Ryle Hall Masonry Repairs 2025

Truman State University

ADDENDUM NO.1 – 09/11/25

TO DOCUMENTS ISSUED ON August 26, 2025

1 EAST ELEVATION
A1 1/8" = 1'-0"

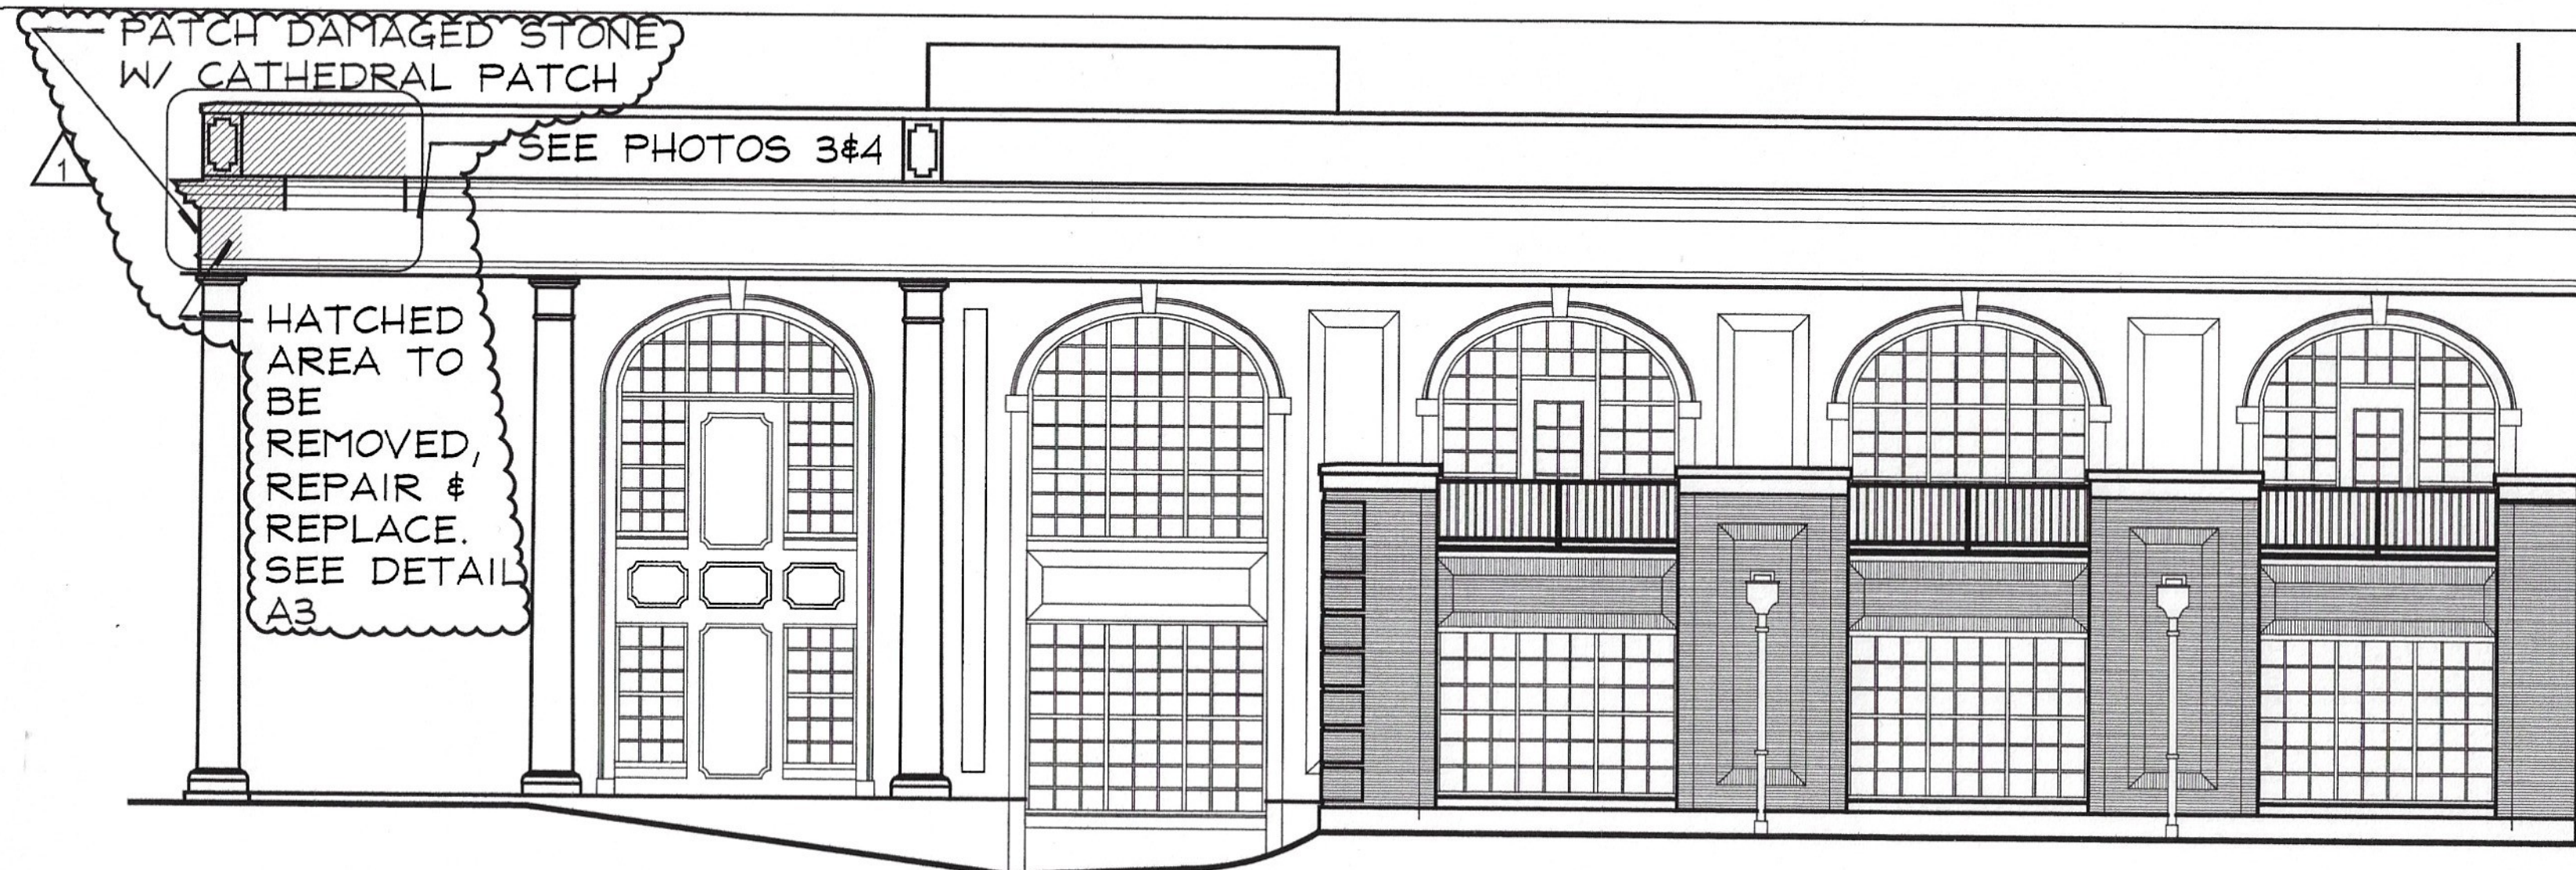
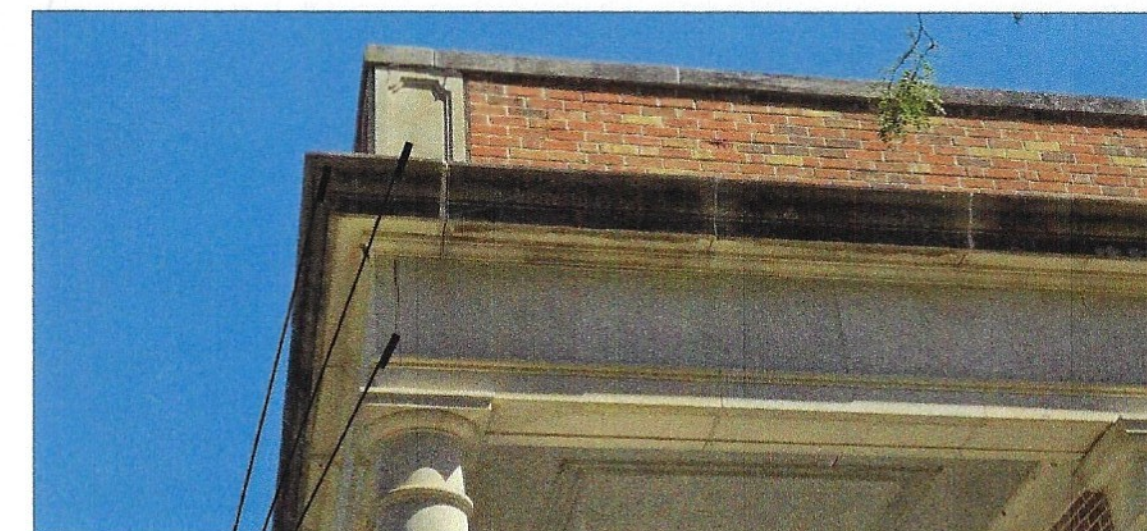
RESET & RESECURE FASCIA STONES. REMOVE & RE-LAY ASSOCIATED COPING STONES & ADJACENT BRICK AS REQUIRED TO RESECURE FASCIA & CORNICE. PROVIDE NEW ANCHORS AS REQUIRED. OPEN & RESECURE ROOFING MEMBRANE AS REQUIRED FOR ACCESS. COORDINATE W/ APPROVED ROOFING COMPANY. COORDINATE W/ ARCHITECT.
